| Title: BOUNDARY TREATMENTS | |
| Job: LAWN ROAD | |
| Dwg. No: FNH413-35.804 | Rev: B |

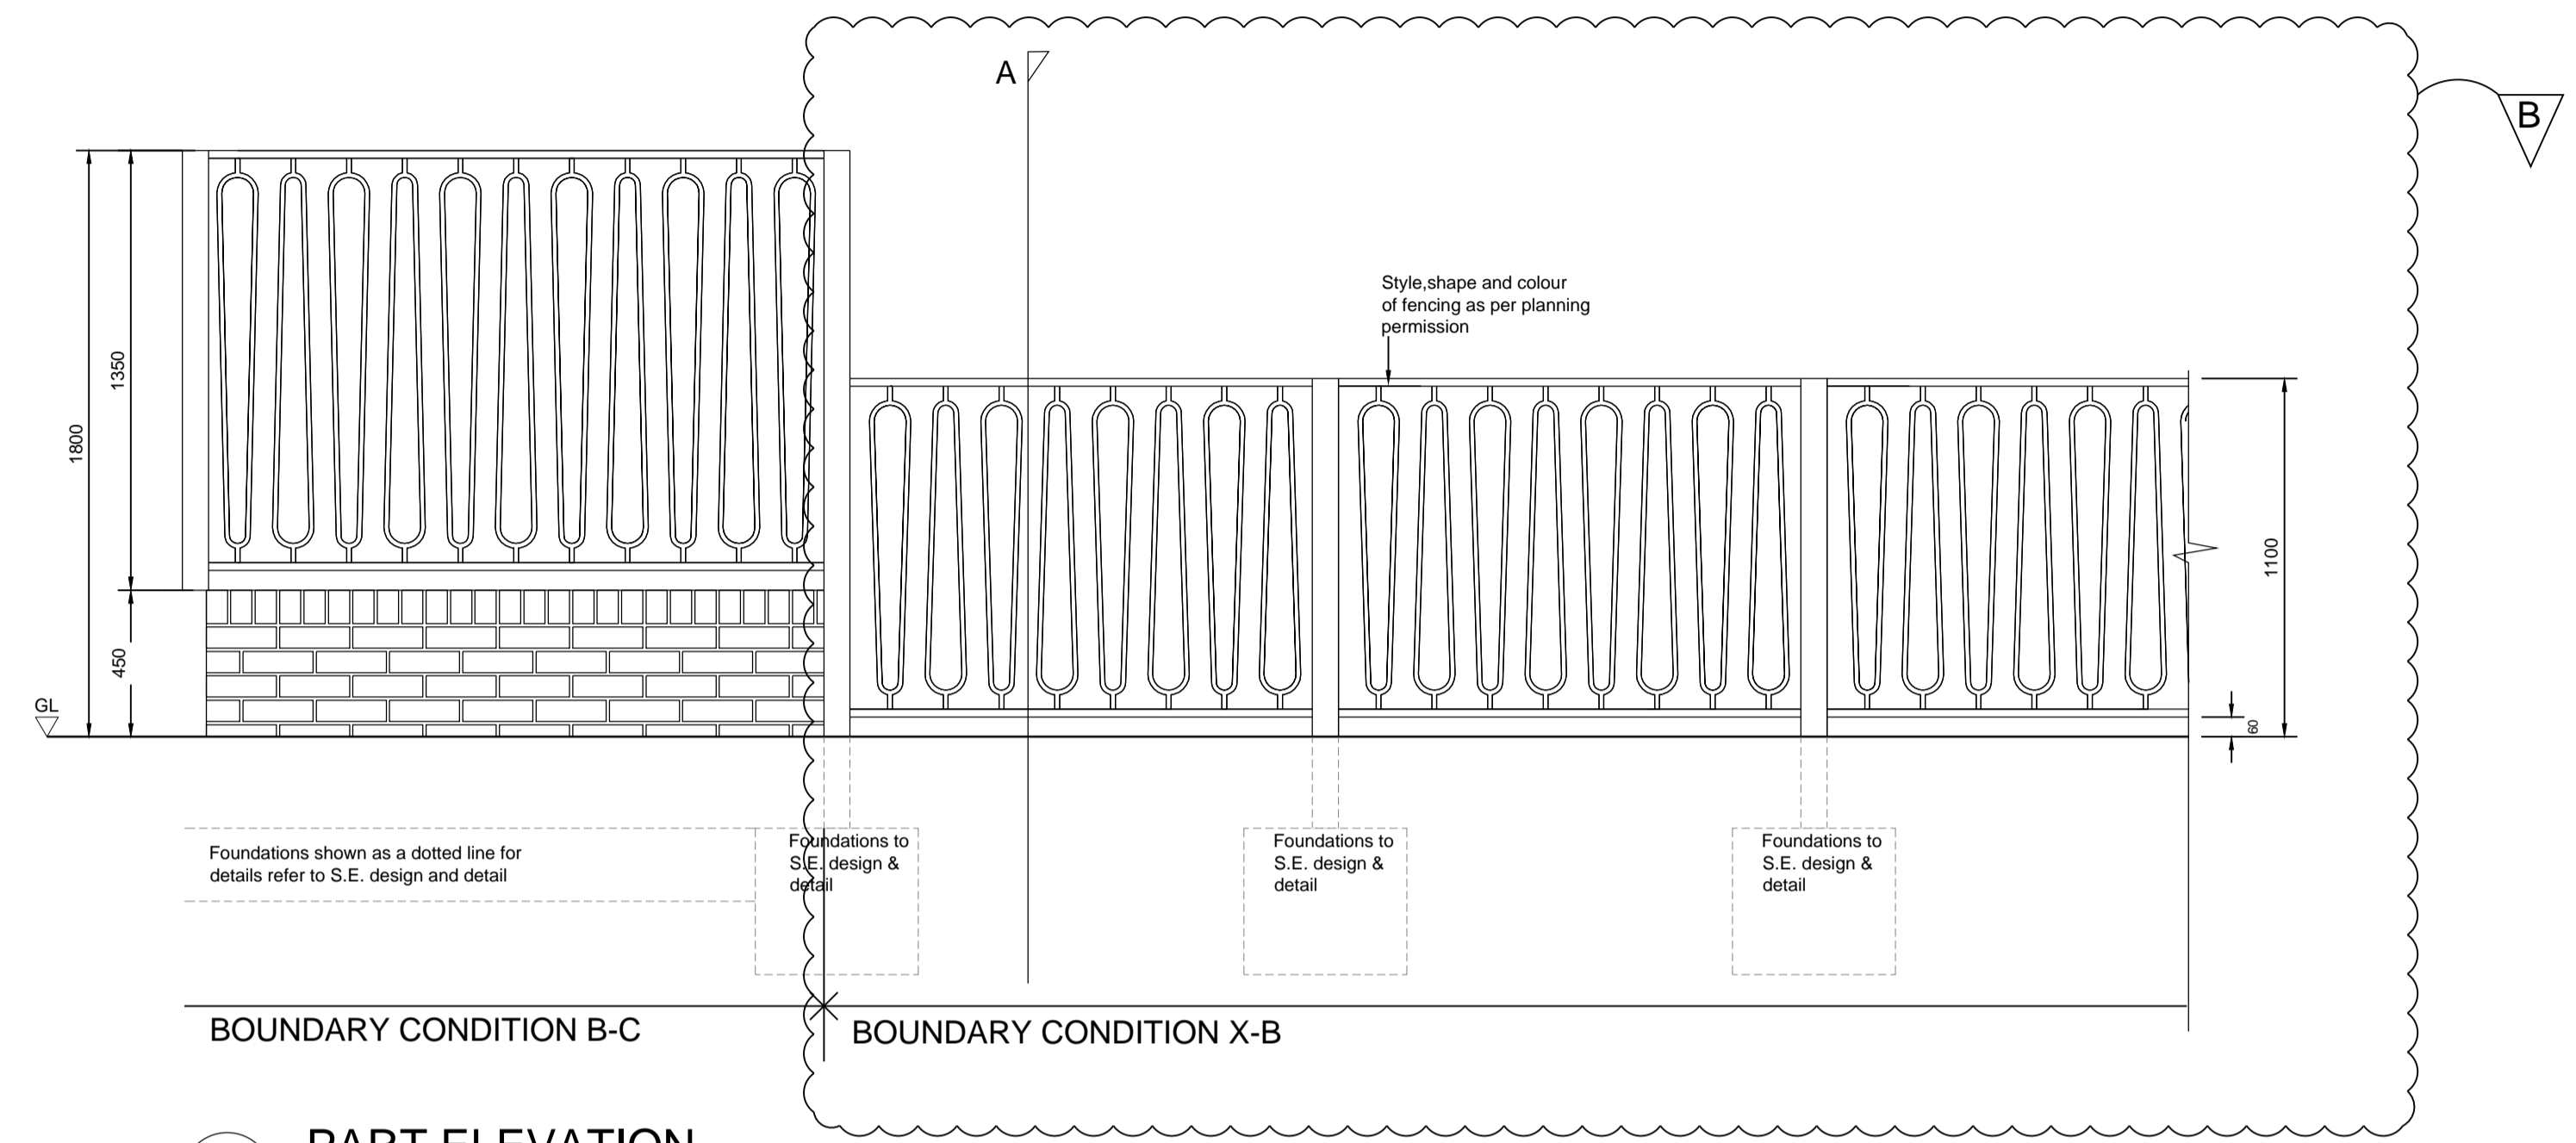
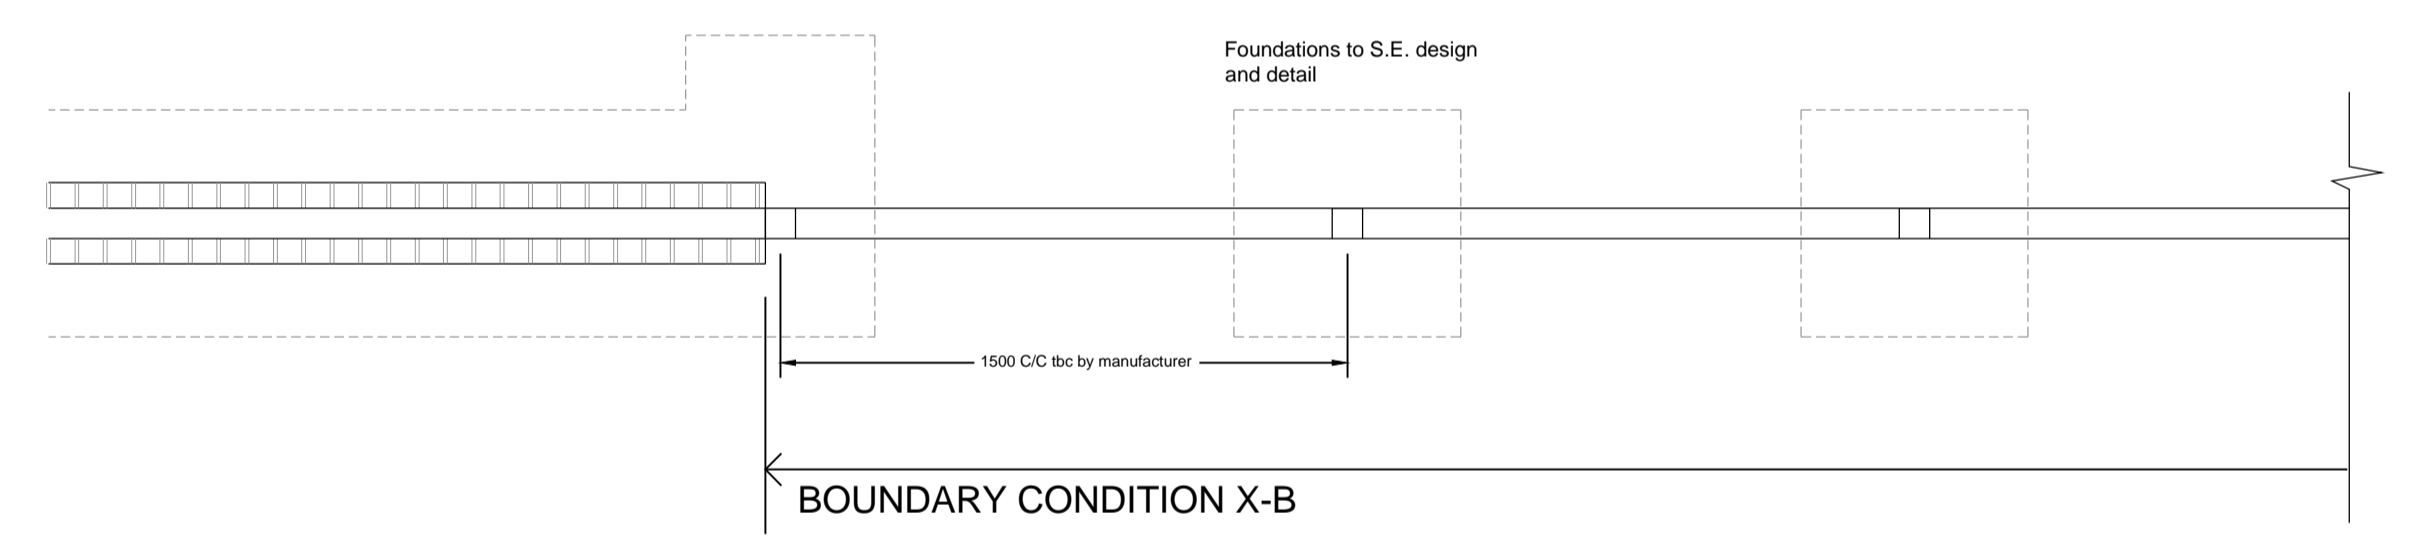
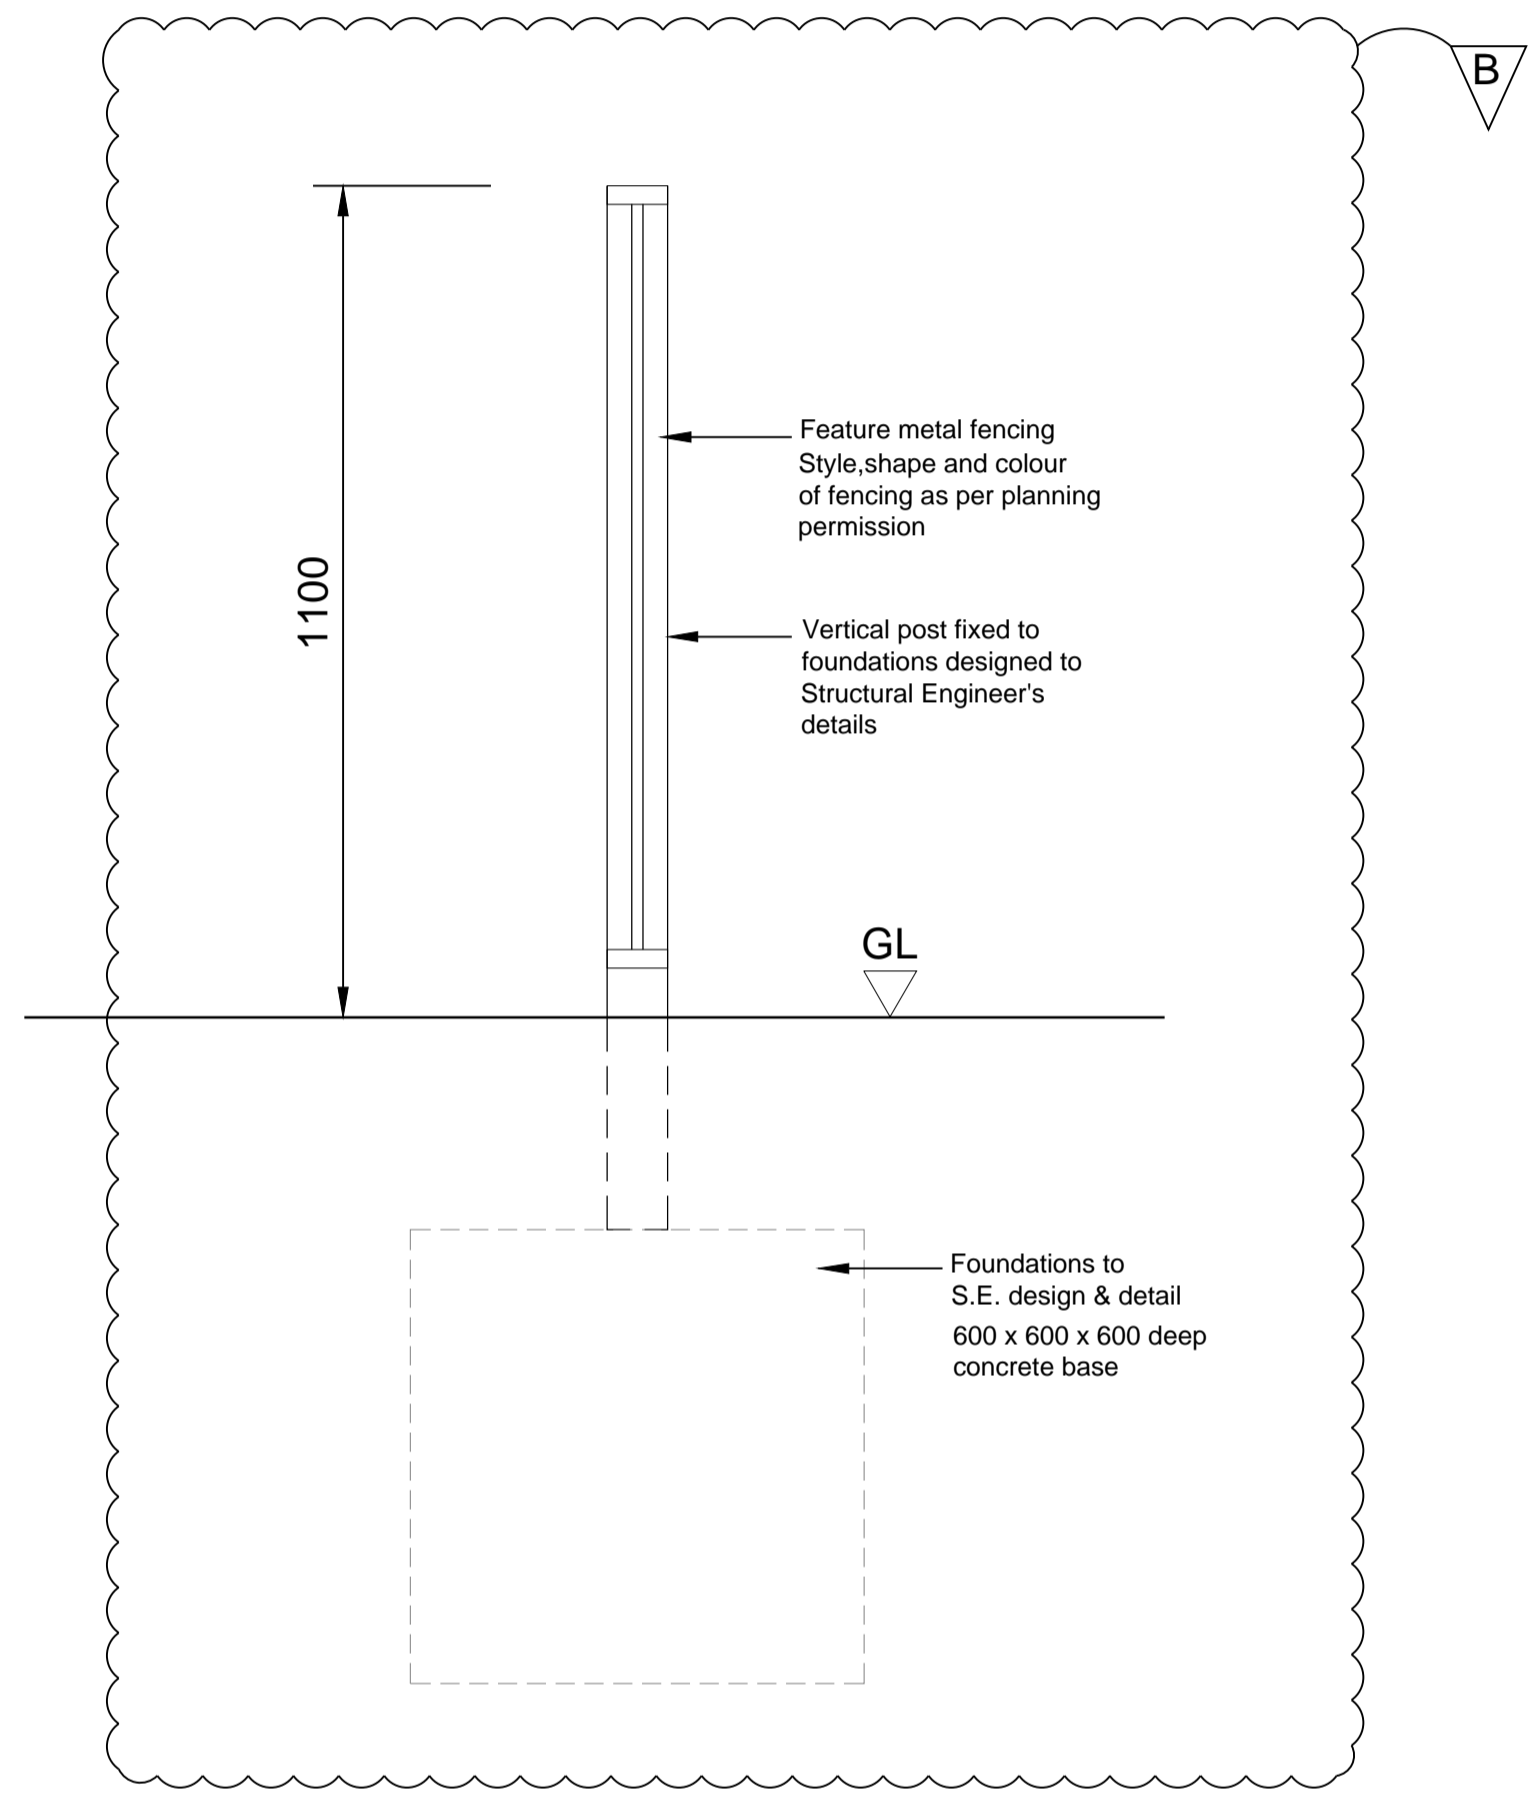
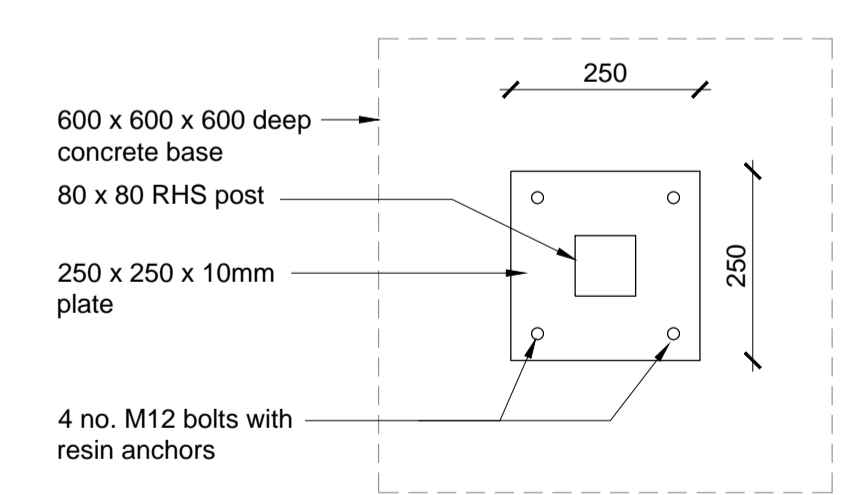
B RFI-4130113- Fence height updated BG 17.06.16
A RFI-4130113- Detail for boundary fence around trees LG 09.06.16
